CROSS RIVER RAIL

Environmental Impact Statement

Request for Project Change

February 2017

Figure 6-11 - Changed Project Northern Portal worksite

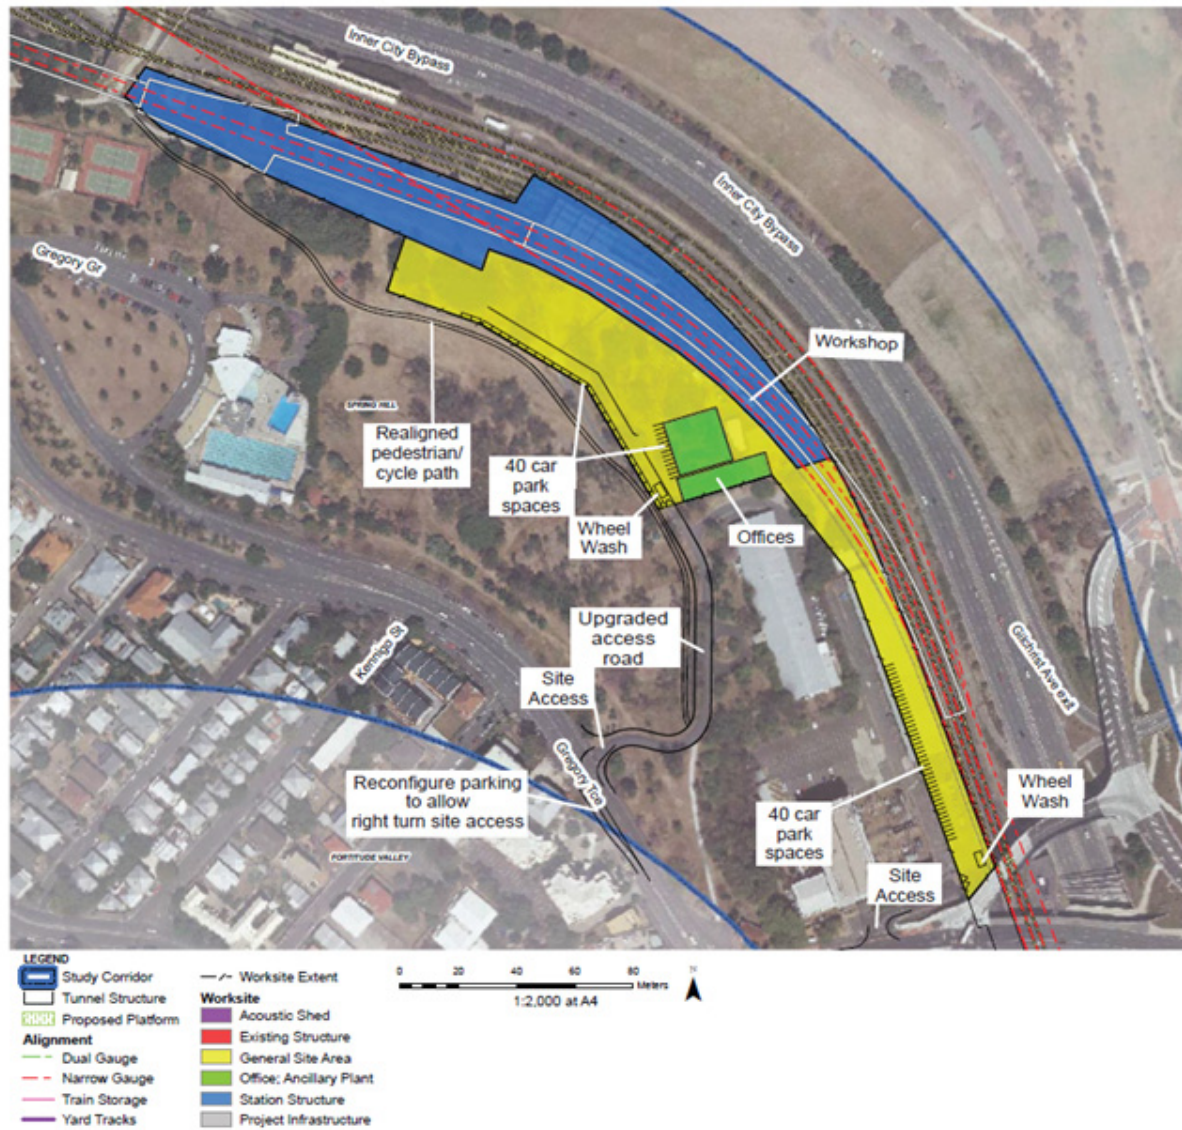
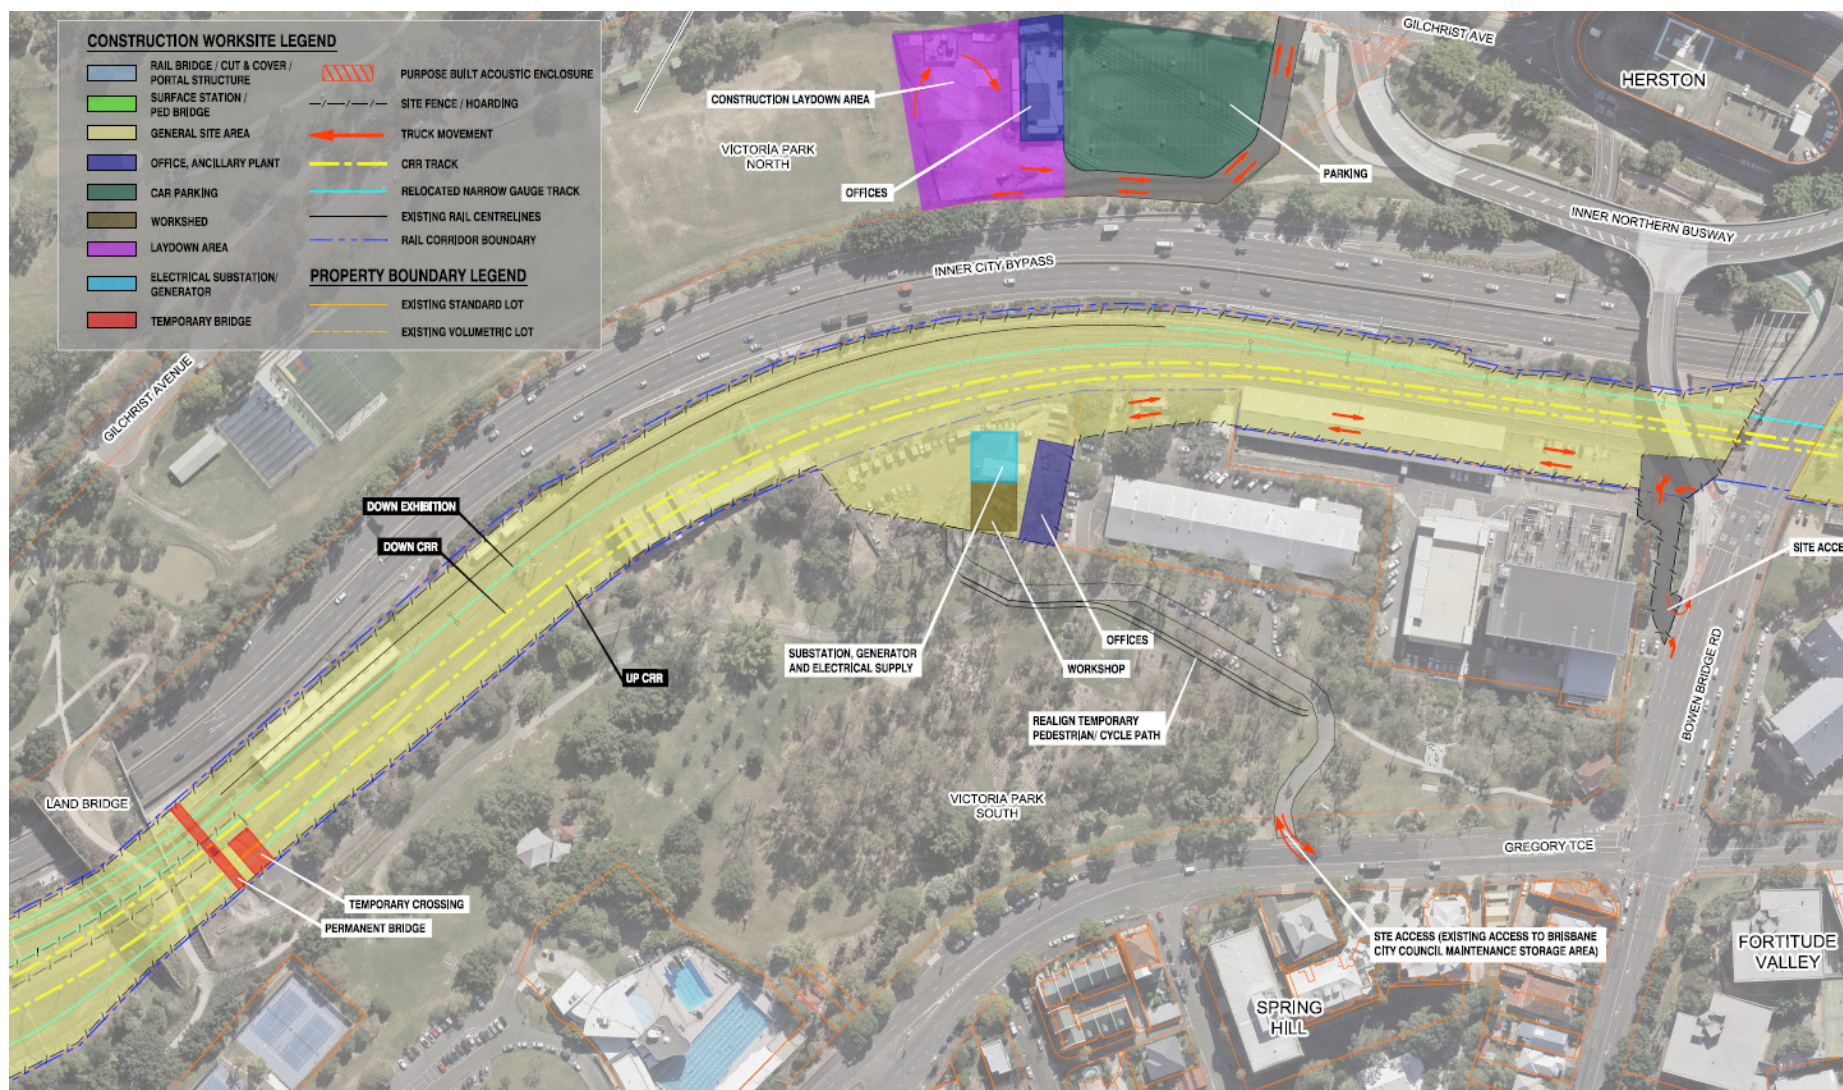
The Northern Portal construction worksite for the Reference Project and the Changed Project are shown in Figure 6-10 and Figure 6-11, respectively.

Figure 6-13 - Changed Project Exhibition Station worksite

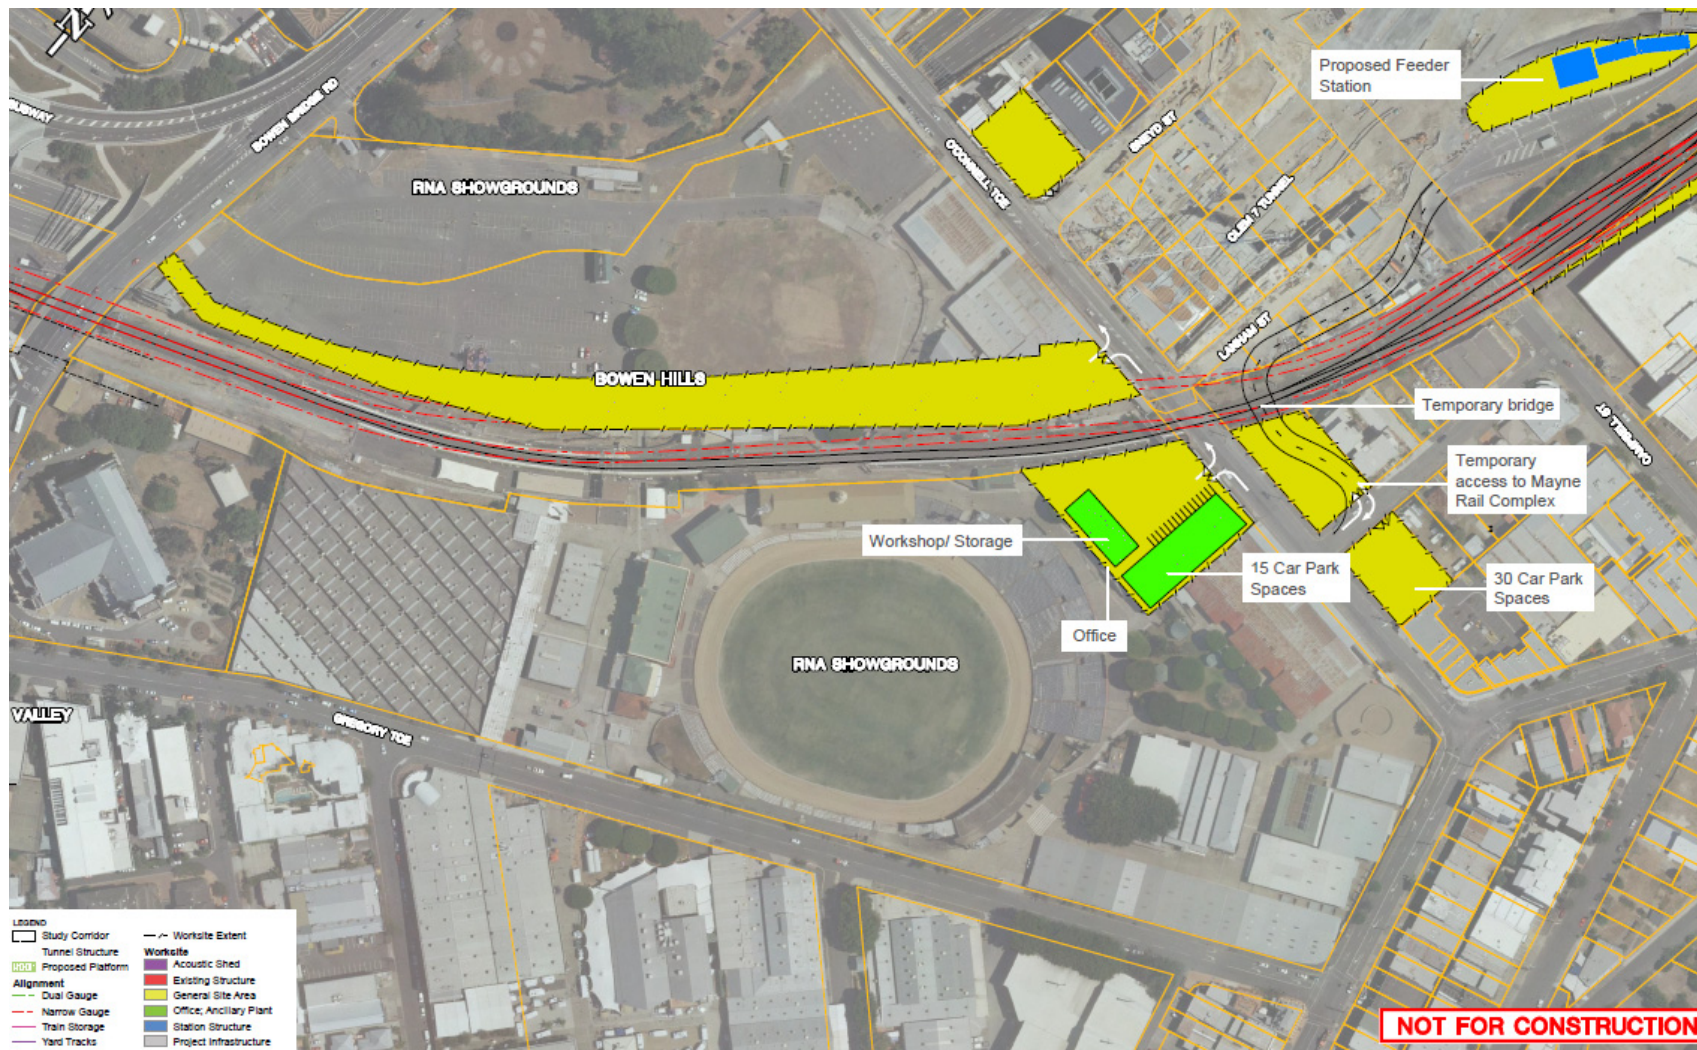
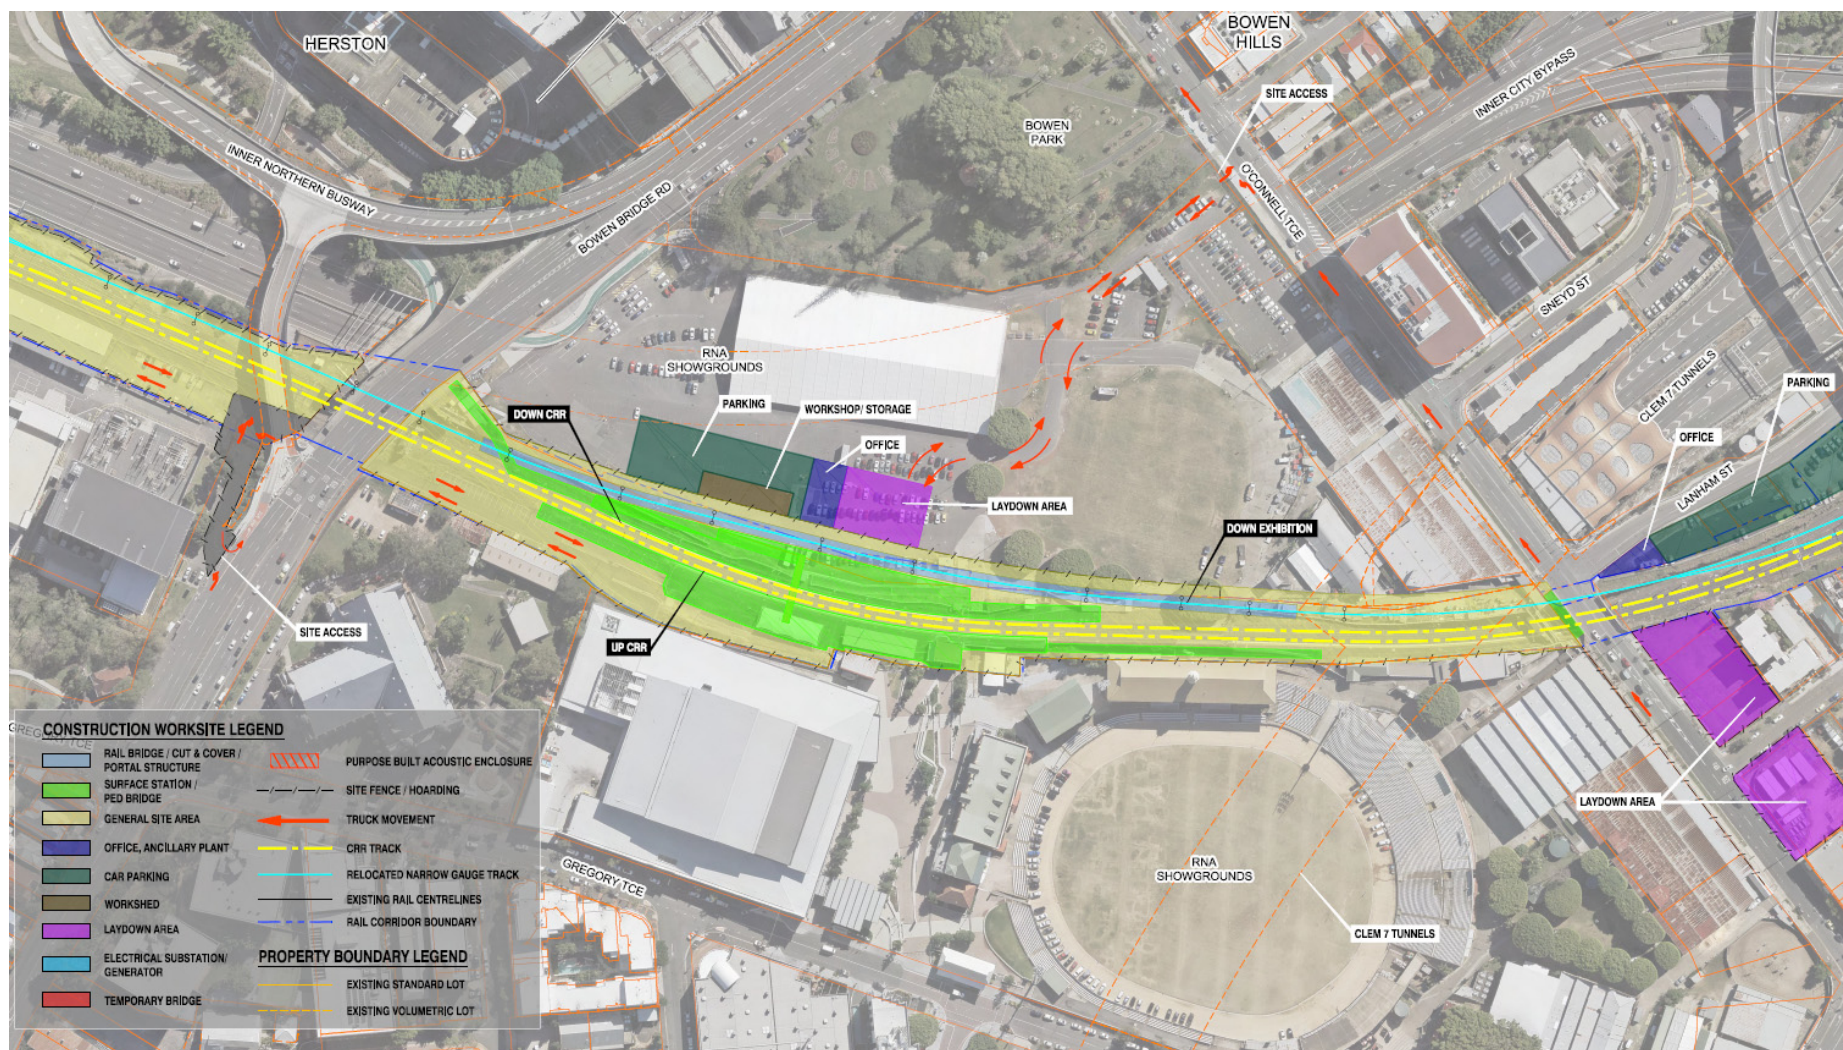
The Exhibition Station worksite for the Reference Project and the Changed Project are shown in Figure 6-12 and Figure 6-13, respectively.

Figure 6-14 - Changed Project Mayne Yard worksite

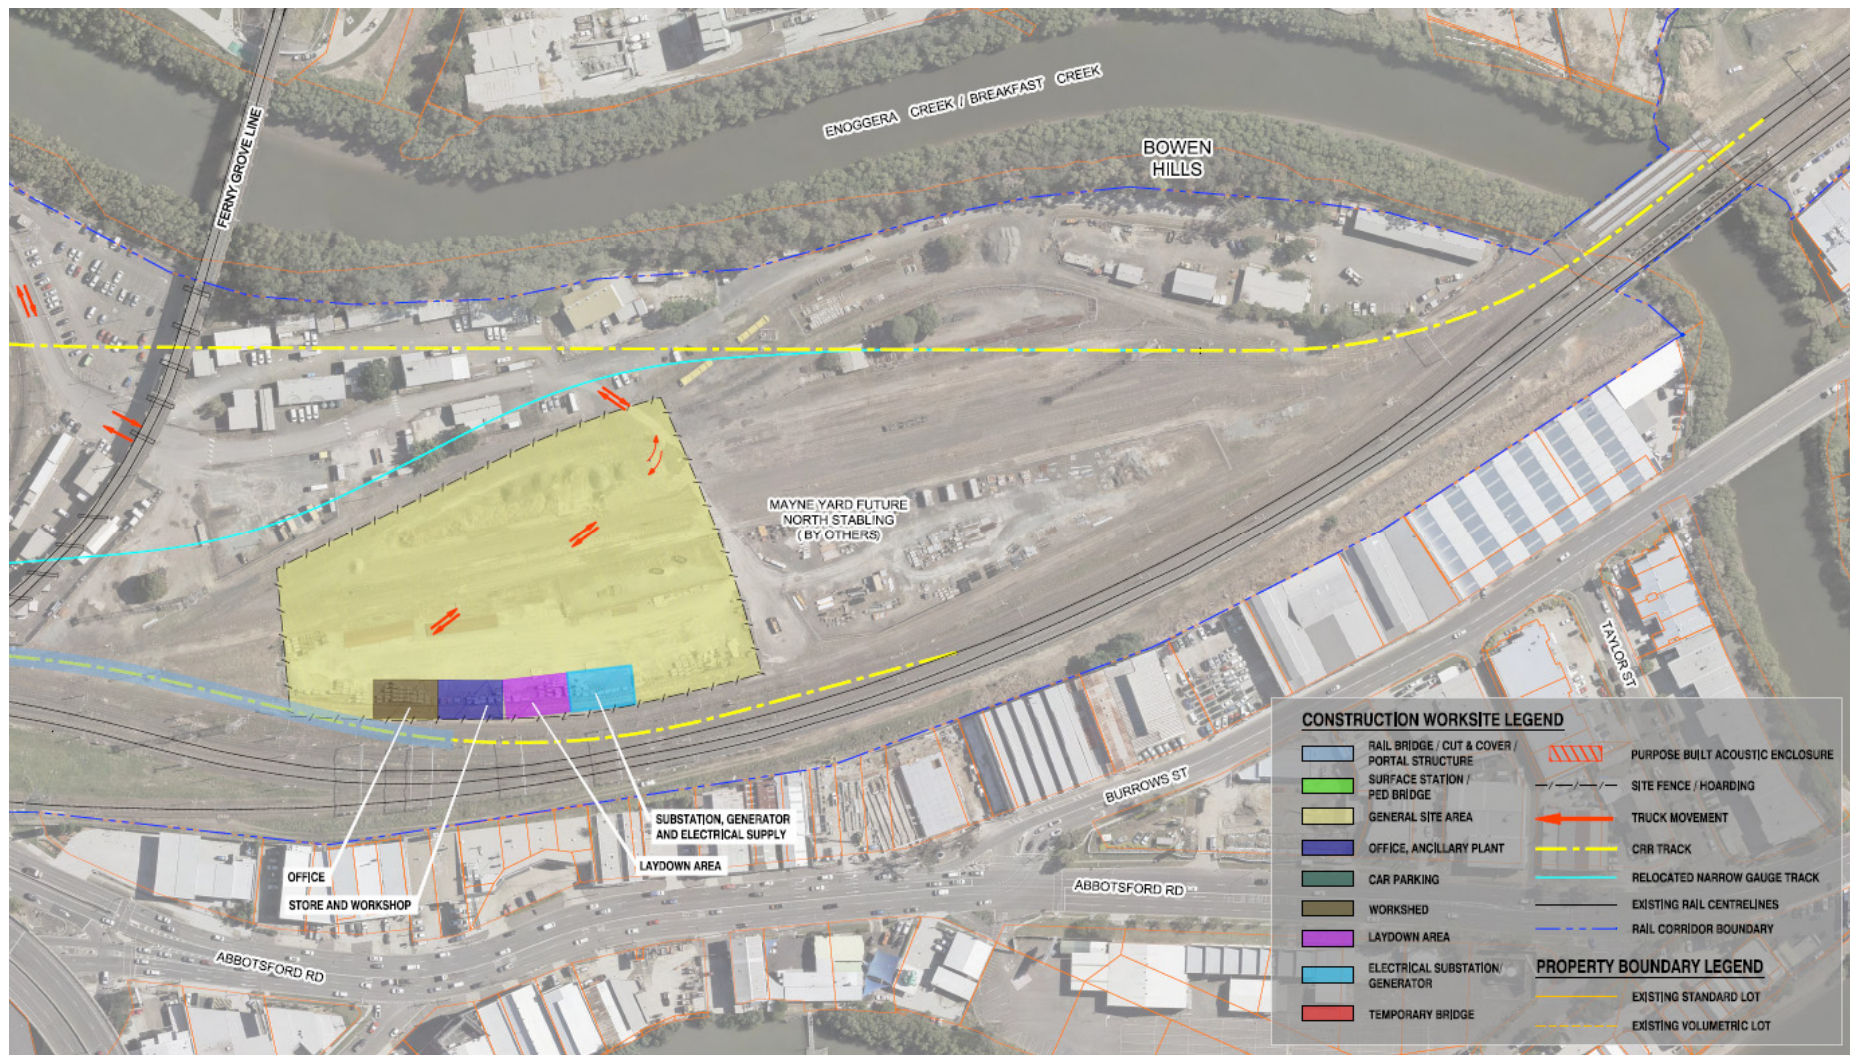
The Mayne Yard construction worksite for the Changed Project is shown in Figure 6-14.
